Gegenstand: Lager der Handsteuerung

Scheibe- Flugzeugbau GmbH August- Pfaltz- Str. 23 85221 Dachau LBA- Anerkennung I- EB 2	Technische Mitteilung 653-47/ 2 	SF 25C: Änd. 86, 109 SF 25 E: Änd. 38, 42 SF 25 K: Änd. 1 Gerätenr.: 653 Blatt 2 von 2
--	---	---

Scheibe- Flugzeugbau GmbH August- Pfaltz- Str. 23 85221 Dachau LBA- Anerkennung I- EB 2	Service Bulletin 653-47/ 2 	SF 25C: Modification 86, 109 SF 25 E: Modification 38, 42 SF 25 K: Modification 1 TCDS-N° 653 Page 1 of 2
--	---	---

Subject: Bearings in the control stick

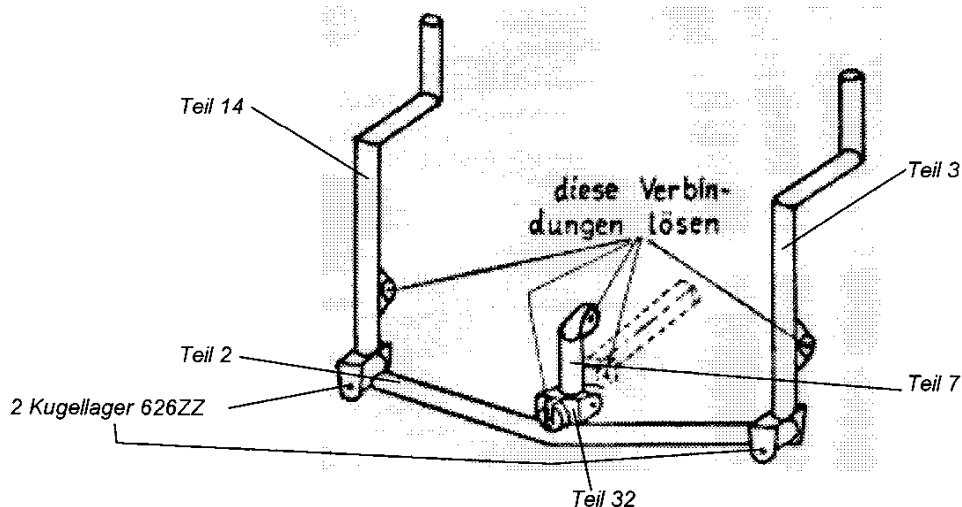
Dringlichkeit: a) Sofort, wenn an einer Lagerstelle der Handsteuerung nach bei liegender
Skizze noch 2-reihige Pendelkugellager 14C6 eingebaut sind oder
b) wenn die mit TM 653-47 vorgeschriebenen Lager GE8E im Schadensfall
ersetzt werden müssen.

Vorgang: Die mit TM 653-47 eingerüsteten Lager GE8E verschleifen sehr schnell.
Außerdem sind diese Lager nicht mehr erhältlich.
Sollen diese Lager erneuert werden, ist daher die gesamte Handsteuerung
(Teil 2, 3, 7, und 14 aus 653E-41-S10) auf den neuen Musterstand nach
653E-41-S10 Änd. d in Verbindung mit Teil 32 nach 653E-41-S10 E1 zu
ändern.

Maßnahmen: An den Teilen 2, 3, 7 und 14 (siehe nachfolgende Abbildung) aus Zeichnung
653E-41-S10 sind neue Lagerringe entsprechend den Zeichnungen
653E-41-S10 Änd. d und 653E-41-S10E1 anzuschweißen.
Anstelle des bisherigen Teil 33 aus 653E-41-S10 ist zwischen Teil 2 und
Teil 7 das Teil 32 aus Zeichnung 653C-41-S10E1 einzubauen
Bis auf das Lager 14C8 auf Teil 2 sind alle anderen Lager als Gleitlager
ausgeführt (1x SSCP 8 IH und 2x SSCP 6 IH). Alle Gleitlager sind mit
Loctite 270 eingeklebt und mit jeweils 2 Seegerringen gesichert.
Zusätzlich sind die 4 Lager 626 ZZ in Teil 2 aus 653E-41-S10 zu erneuern.

Material: 2x Lagerringe Teil 35 Änd. d und 1x Lagerring Teil 6 Änd. d nach Zeichnung 653E-41-S10 Änd. d und 1x Lagerring nach 653E-41-S10E1

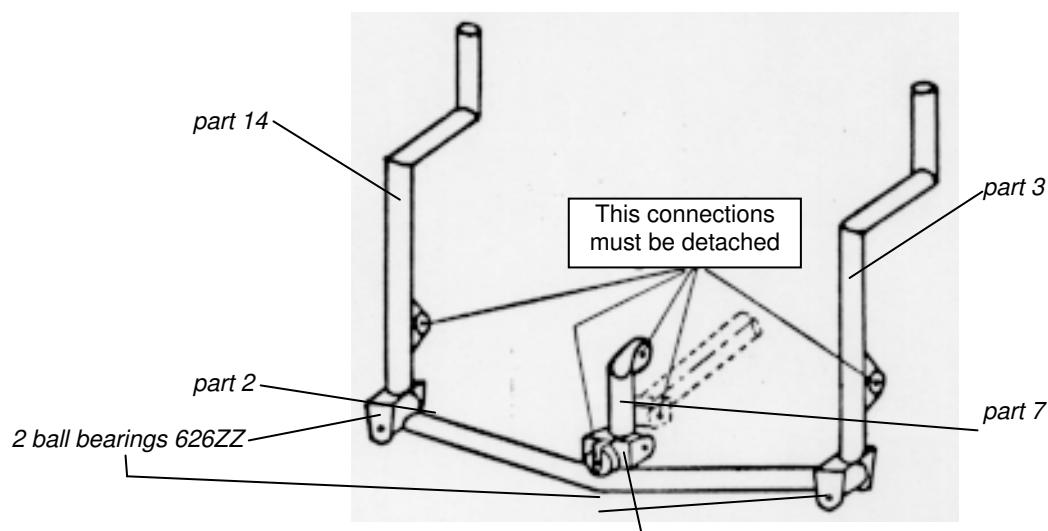
Urgency: a) Before the next flight, if a double-row self aligning ball bearing 14 C 6 is to be found in the control column parts 2, 3, 7 and/or 14 (see below sketch) or
 b) when the spheric slide bearings GE 8 E installed in accordance with TM 653-47 are worn out and must be replaced.

Reason: The spheric slide bearings GE 8 E according to TM 653-47 wear out very soon and are no longer obtainable.
 If these spheric slide bearings must be replaced, the complete control column (Parts 2, 3, 7 and 14 according to 653E-41-S10 and part 32 according to 653E-41-S10E1) must be modified according to 653E-41-S10 change d.

Actions: New slide bearing supports must be welded to the parts 2, 3, 7 und 14 (see below sketch) according to 653E-41-S10 change d and 653E-41-S10E1.
 The old Part 33 of 653E-41-S10 located between part 2 and 7 is to be replaced by the new part 32 according to 653E-41-S10E1.
 With the exception of the spheric ball bearing 14 C 8 at part 2 of 653-41-S10E1 all the other bearings are spheric slide bearings (1x SSCP 8 IH und 2x SSCP 6 IH). All the slide bearings are fixed with Loctite 270. Apply 2 new chime rings at each bearing.
 Replace the additional 4 ball bearings 626 ZZ at part 2 of 653E-41-S10.

2x bearing supports (part 35 of 653E-41-S10 change d)	and
1x bearing support (part 6 of 653E-41-S10 change d)	and
1x bearing support (part 2 of 653E-41-S10E1)	
Spheric slide bearing	1x SSCP 8 IH with 2x chime rings
	and 2x SSCP 6 IH with 2x chime rings
Spheric ball bearings	1x 14C8 with 2x chime rings
Ball bearing	4x 626 ZZ
